A PROJECT FOR:  
**Cason Graye Homes**  
PROJECT LOCATION:  
4805 Elm Street, Bellaire, TX.  
Lot 1 Block 1  
Subd. Wheelshire

DATE	CHECK SET	CITY COMMENTS
MA 12/8/2021		
MA 2/18/2021

SHEET NO.  
**1** OF **11**

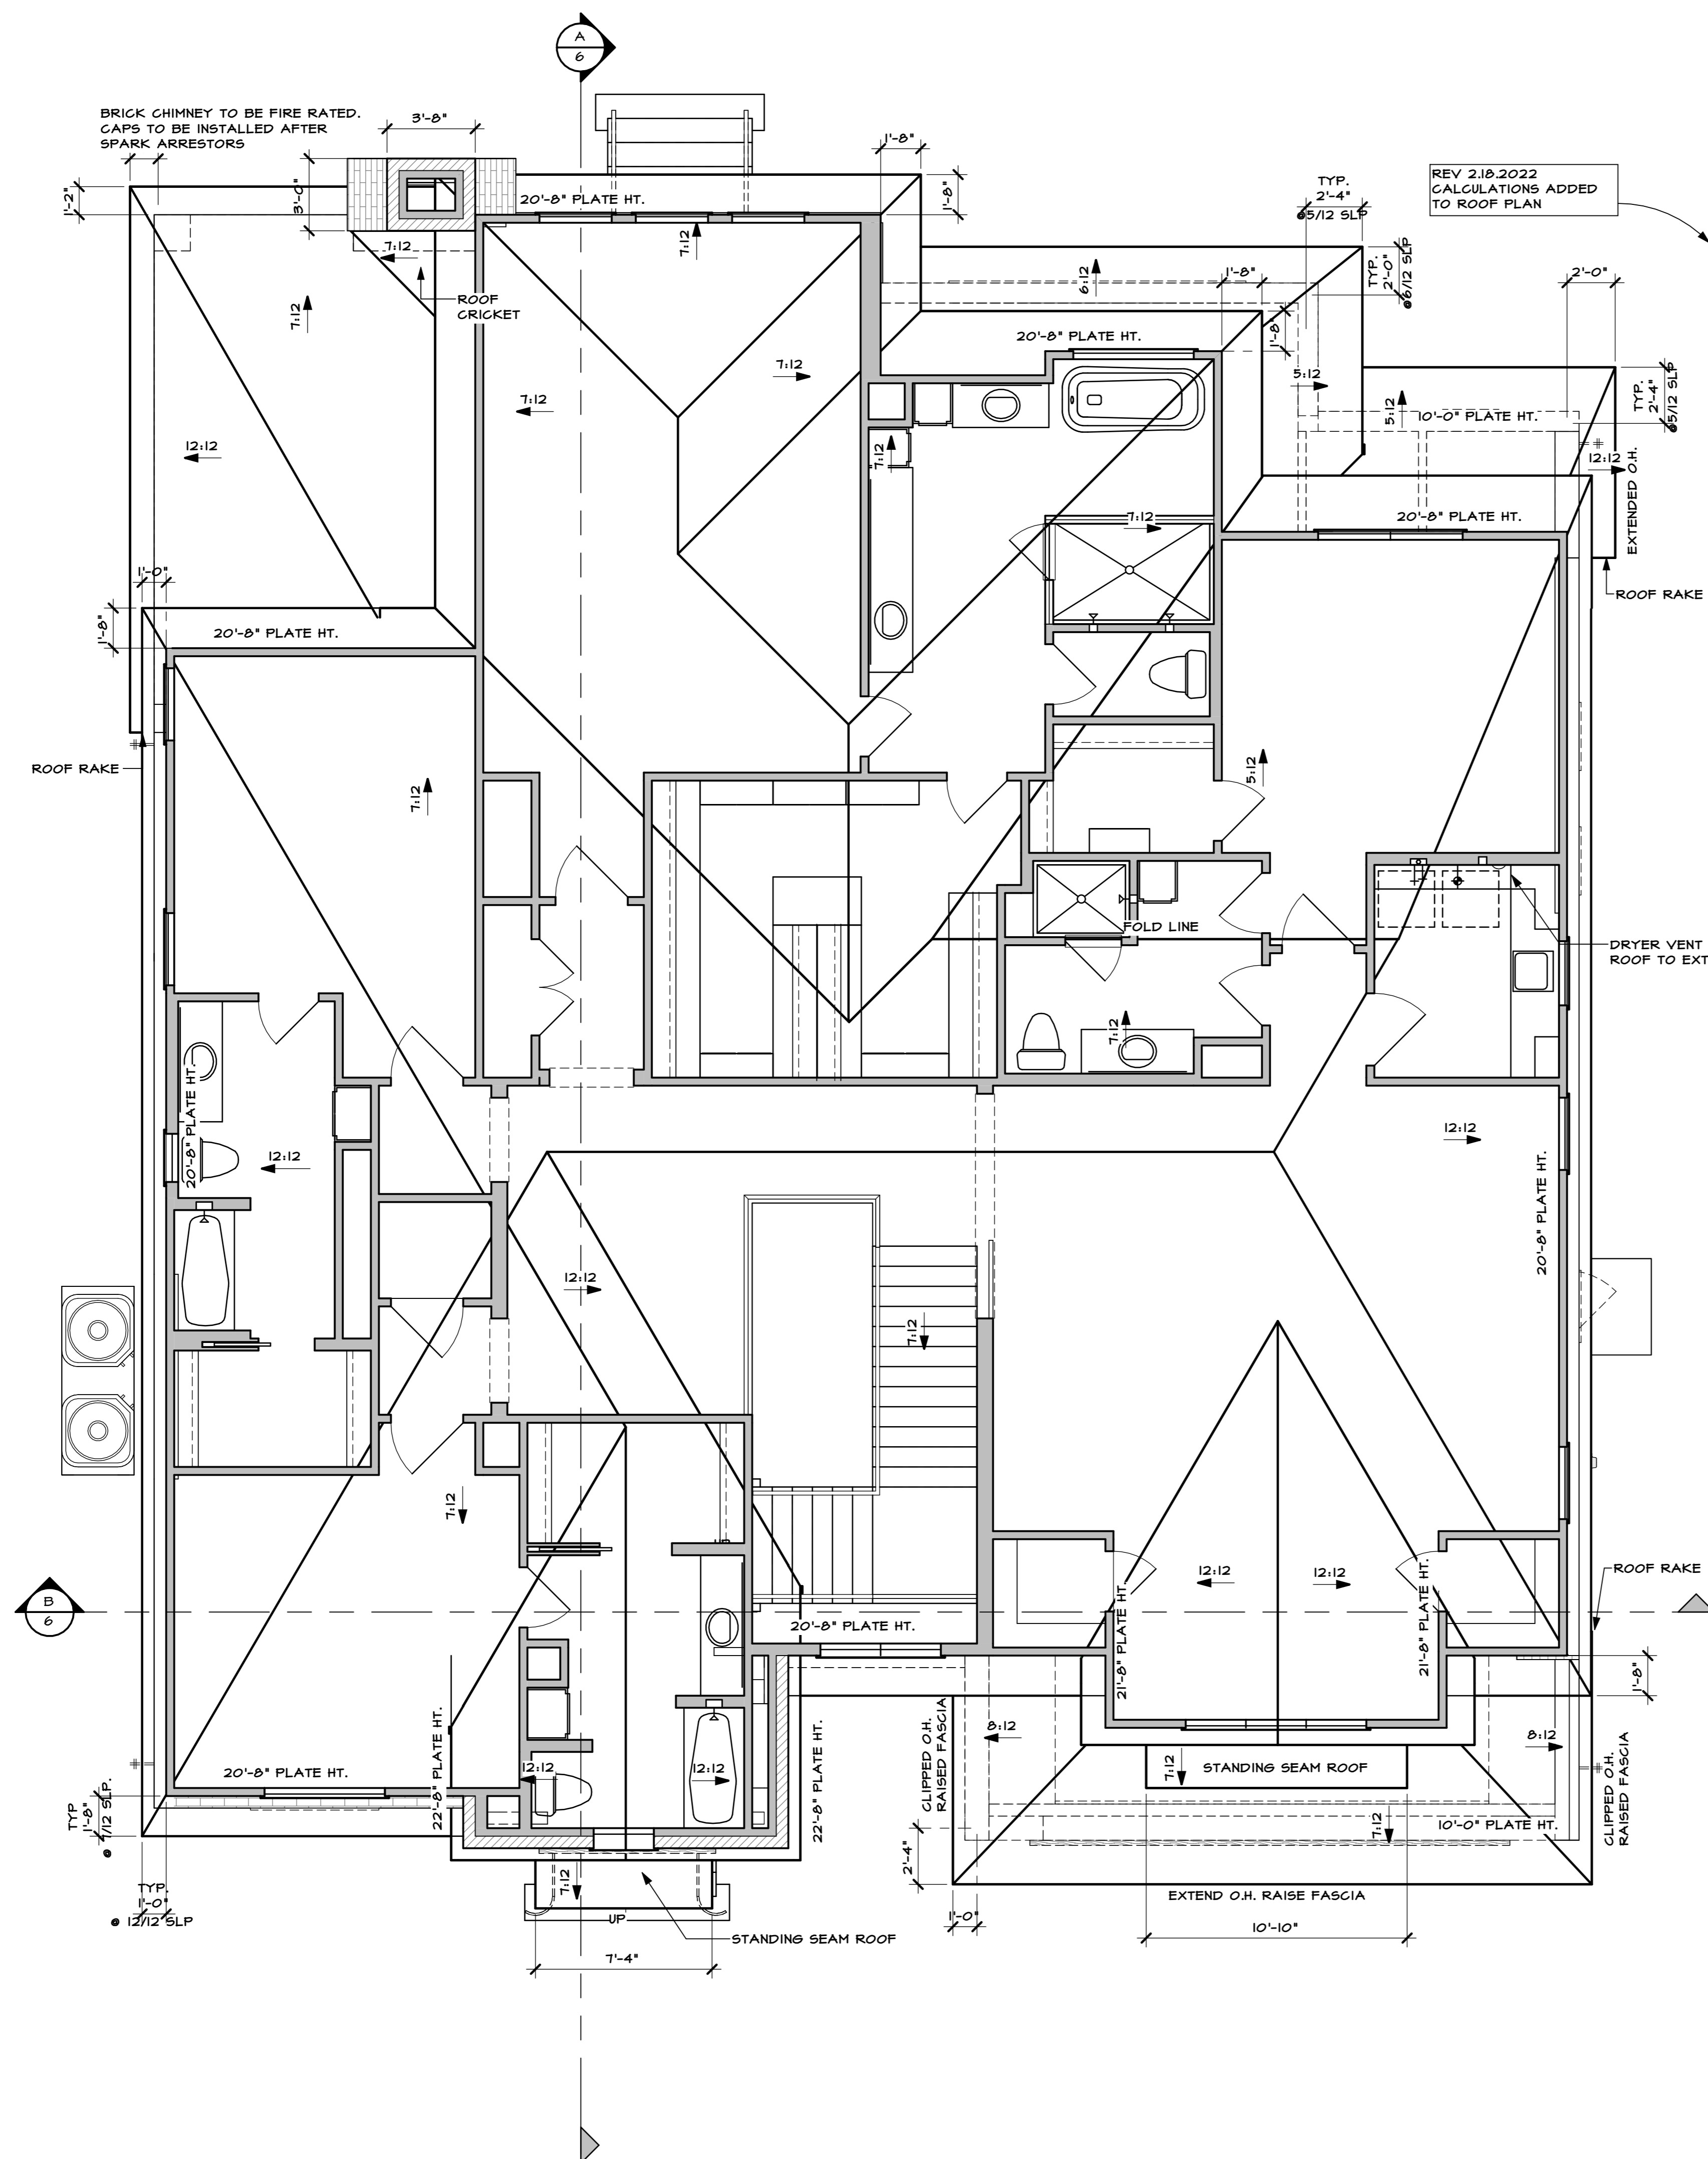
REV 2.18.2022  
CALCULATIONS ADDED  
TO ROOF PLAN
